# UNITED STATES PATENT AND TRADEMARK OFFICE

APPLICATION NO.	FILING DATE	FIRST NAMED INVENTOR	ATTORNEY DOCKET NO.	CONFIRMATION NO.
10/766,684	01/28/2004	Nabil L. Muhanna	126013-1003	2069

<b>Office Action Summary</b>	<b>Application No.</b> 10/766,684	<b>Applicant(s)</b> MUHANNA ET AL.	
	<b>Examiner</b> Bruce E. Snow	<b>Art Unit</b> 3738

## DETAILED ACTION

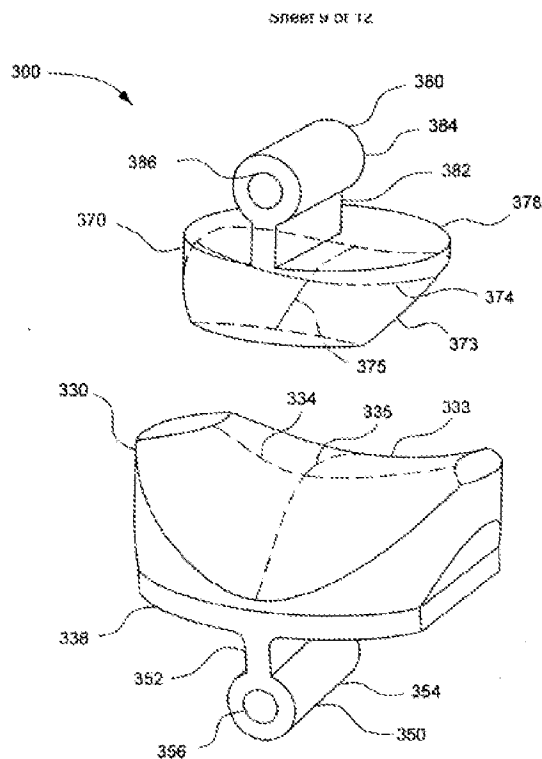
Regarding the rejection under 35 U.S.C. 102(b) as being anticipated by Shelokov (6,039,763), applicant suggest the surface is as shown:

It is agreed that applicant's drawing shows the articulating surface as being concave along the mid-sagittal plane. However, the Examiner notes that the joint of Shelekov

comprises complementary articulating surfaces of two components. It is the Examiner strong opinion that the articulating surface of the complementary component (see figure 1b) would be convex along the mid-sagittal plane such that they would be "complementary". **Shelokov teaches that this complementary plane P1 is convex. See 5:66-6:3 and figure 1b.**

FIG. 1b

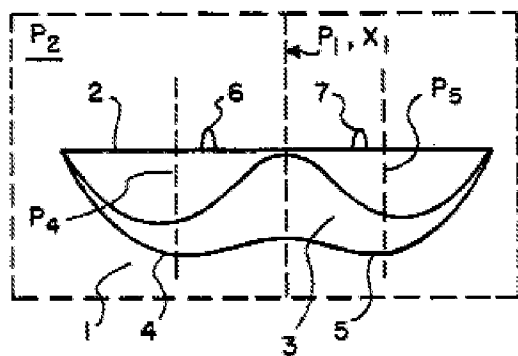
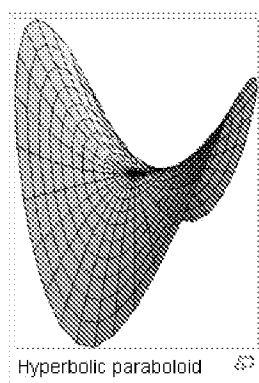
Shelokov teaches a prosthetic disc comprising:  
a first and second disc bodies 1, 10 having complimentary saddle shaped articulating surfaces each surface being one of concave and convex in a first plane and the other of concave and convex in a perpendicular plane to the first. Shelokov teaches, “*the articulating surfaces (3,12) can be regularly or irregularly shaped as at least partially complementary portions of.. paraboloids (6:51 et seq.)*.”

Referring to the first and second disc bodies of Shelokov, the articulating surface 3, 12 (between lines P4 and P5) are a clearly a hyperbolic paraboloid shape and not an elliptic paraboloid. As quoted above, the surfaces can be regular shape paraboloids which are hyperbolic as taught from the drawings. Hyperbolic paraboloids are inherently concave-convex. Shelokov teaches that the plane P1 is convex; see 5:66-6:3. Additionally, Shelokov teaches the articulating surfaces can be a hyperboloid which meets all claims. Same for claim 35.

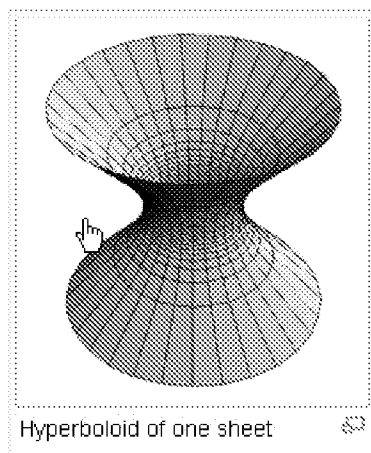
Regarding claim 19, a midsagittal plane is solely convex.

Note that the second surface 2 of body 1 is fixed relative to the articulating surface 3.

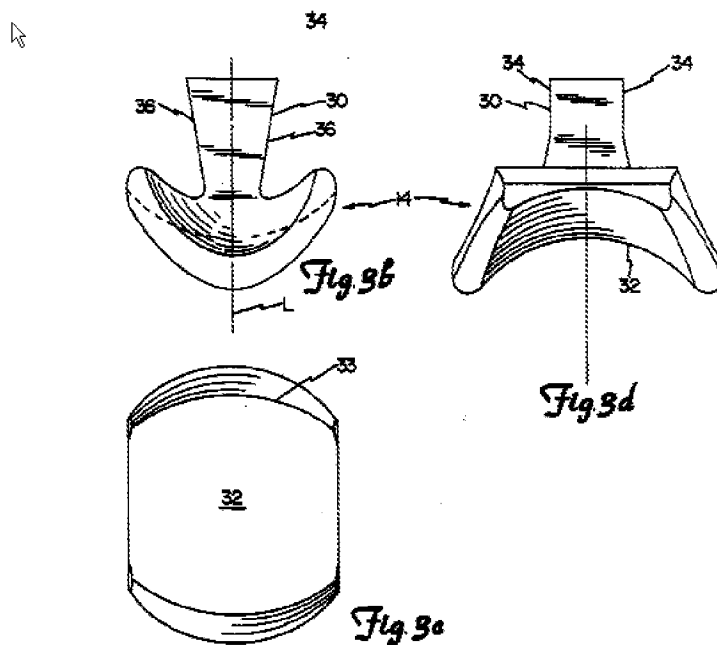
Regarding claim 42, "the superior articulating surface has a single shape characterized as a hyperbolic paraboloid", the single shape of portions 3, 12 is a hyperbolic paraboloid.
